The Commission has issued the enclosed Amendment No. 87 to Facility Operating License No. DPR-32 for the Surry Power Station, Unit No. 1. The amendment consists of changes to the Technical Specifications in response to your application transmitted by letter dated April 14, 1983.

The amendment revises the Technical Specifications to raise the control rod bank insertion limits.

SURRY POWER STATION, UNIT NO. 1

Amendment No. 87
License No. DPR-32

FIGURE 3.12-1A CONTROL BANK INSERTION LIMITS FOR 3-LOOP
NORMAL OPERATION-UNIT 1

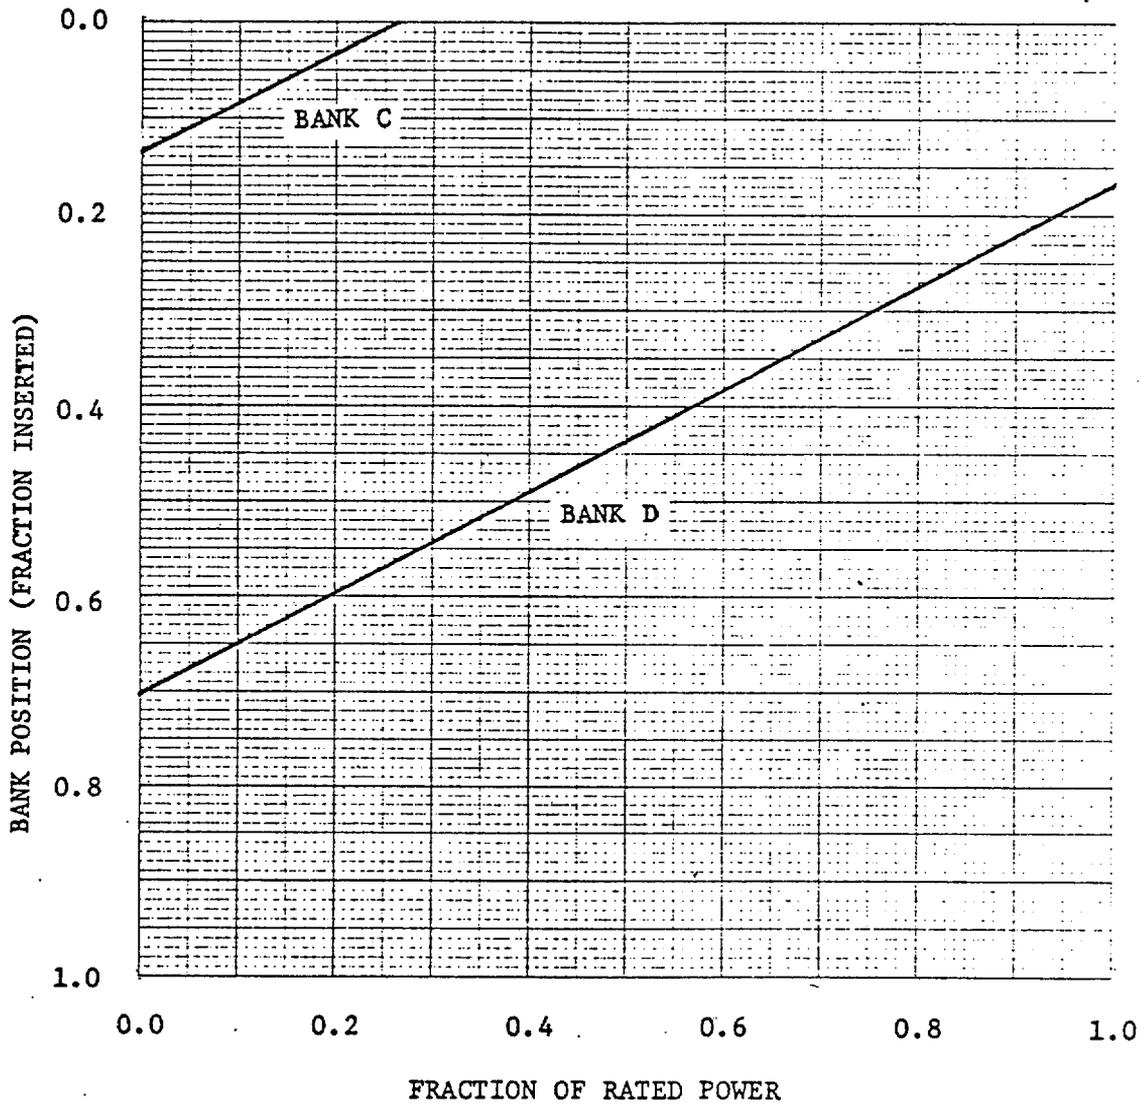
Revise Appendix A as follows:

Figure 3.12-1A

Figure 3.12-1A

The revised core loading configuration required another reload Safety Evaluation. The reload Safety Evaluation provided is based on analysis performed by Westinghouse in accordance with the methodology documented in Westinghouse Topical Report WCAP-9272. The results indicated that no key analysis parameters would become more limiting during Cycle 7 operation than the values assumed in the currently applicable safety analysis. The basis of this evaluation include the assumption of a revision to the presently approved control rod insertion limits. The revised insertion limits are required to meet the current radial power peaking factor design limits for Cycle 7 operation.

We have reviewed the proposed Technical Specification on control rod insertion limits and conclude that they are acceptable since the insertion limits have been obtained using methods previously approved by NRC.
